STATE OF NORTH CAROLINA
DEPARTMENT OF TRANSPORTATION

Subject: Permit Modification Request for **Nationwide Permit 23, 401 Water Quality Certification, and Tar-Pamlico Riparian Buffer Authorization** for the proposed replacement of Bridge Nos. 127 over the Tar River Overflow and 129 over the Tar River on SR 1565 in Pitt County. TIP No. B-3684; Federal Aid Project No. BRSTP-1565(4); State Project No. 8.2221101. Debit \$475 from WBS No. 33225.1.1

PITT COUNTY
 PROJECT: B-3684
 BRIDGE NO. 129 OVER TAR RIVER
 AND BRIDGE NO. 127 OVER TAR RIVER OVERFLOW
 Rev. 9/24/2010

PROJECT REFERENCE NO. B-3684	SHEET NO. 5
ROADWAY DESIGN ENGINEER	HYDRAULICS ENGINEER
Buffer Drawing	
Sheet 7 of 9	
Rev. 9/24/10

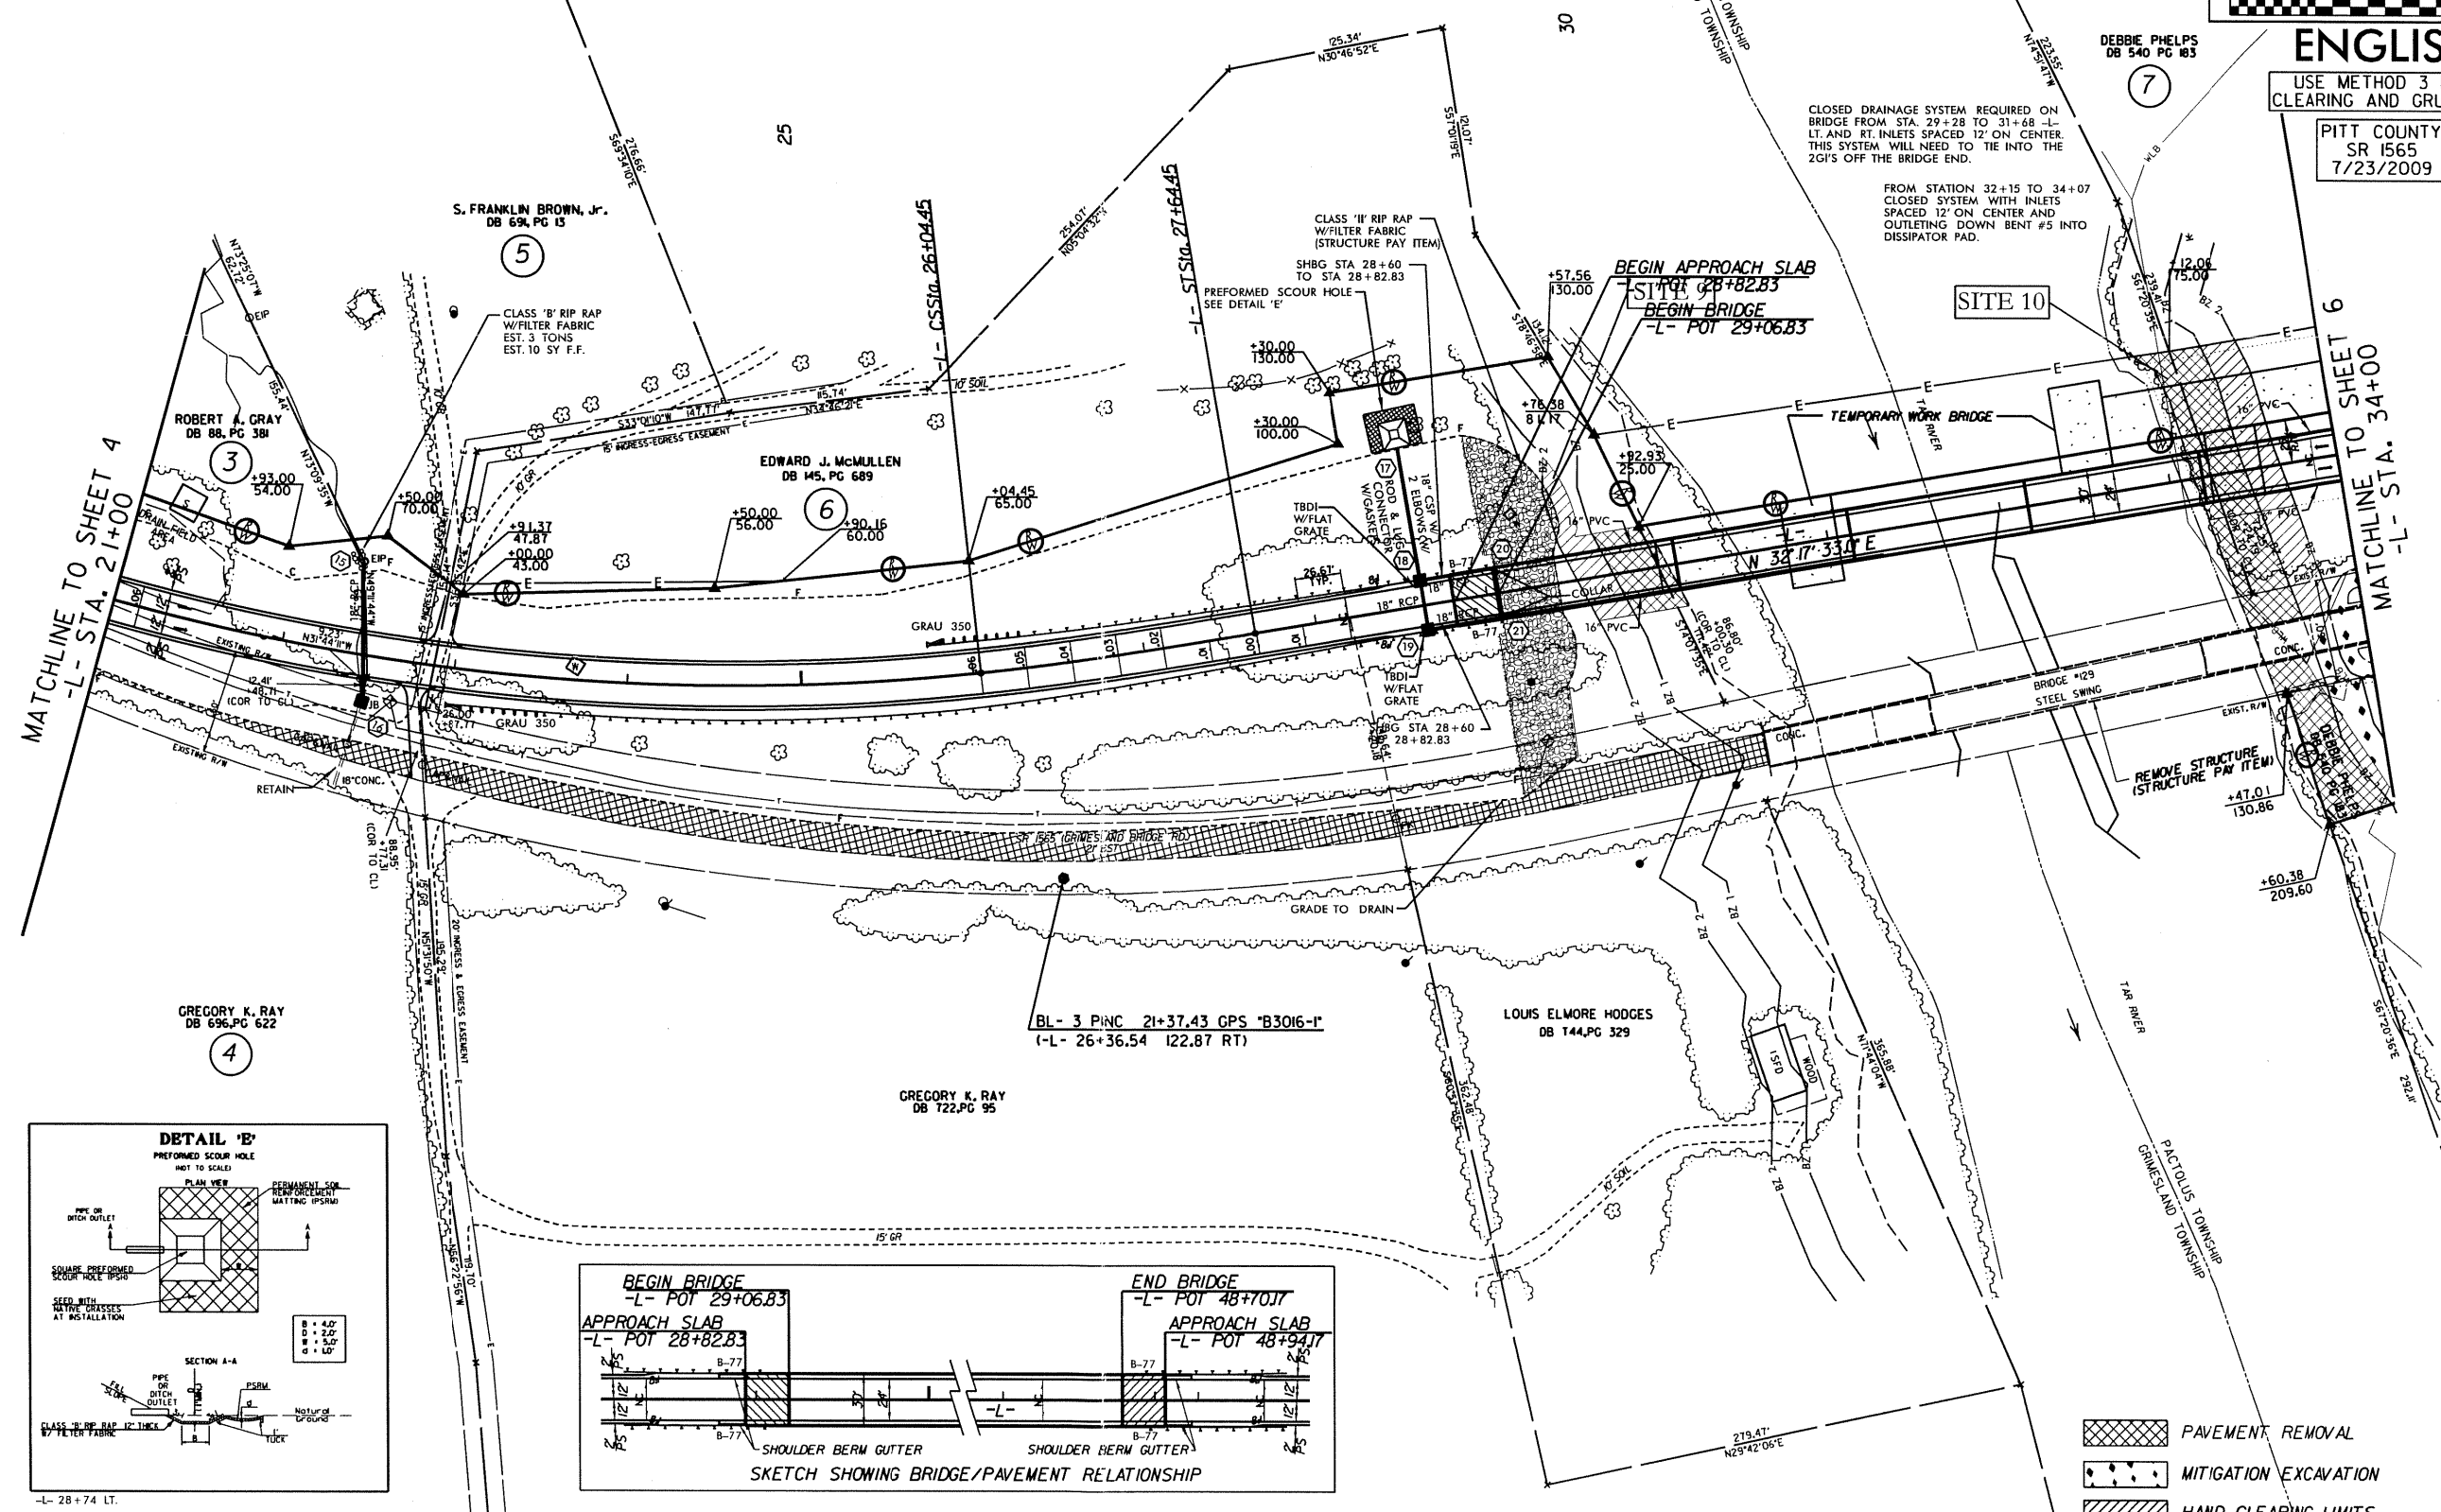
Please see the enclosed revised permit drawings and buffer drawings for the above referenced project. Additional hand clearing in riparian wetland (0.15 acre) at Site 3 (St 29+18 to St 52+65) and 6,213 ft² of impacts to riparian buffers at Site 10 (St 33+02 to St 33+70) are necessary to facilitate bridge removal and construction. This brings total project hand clearing to 3.55 acres and total project buffer impacts to 28,770 ft². In addition, NCDOT is requesting the permit expiration date be extended to March 18, 2012.
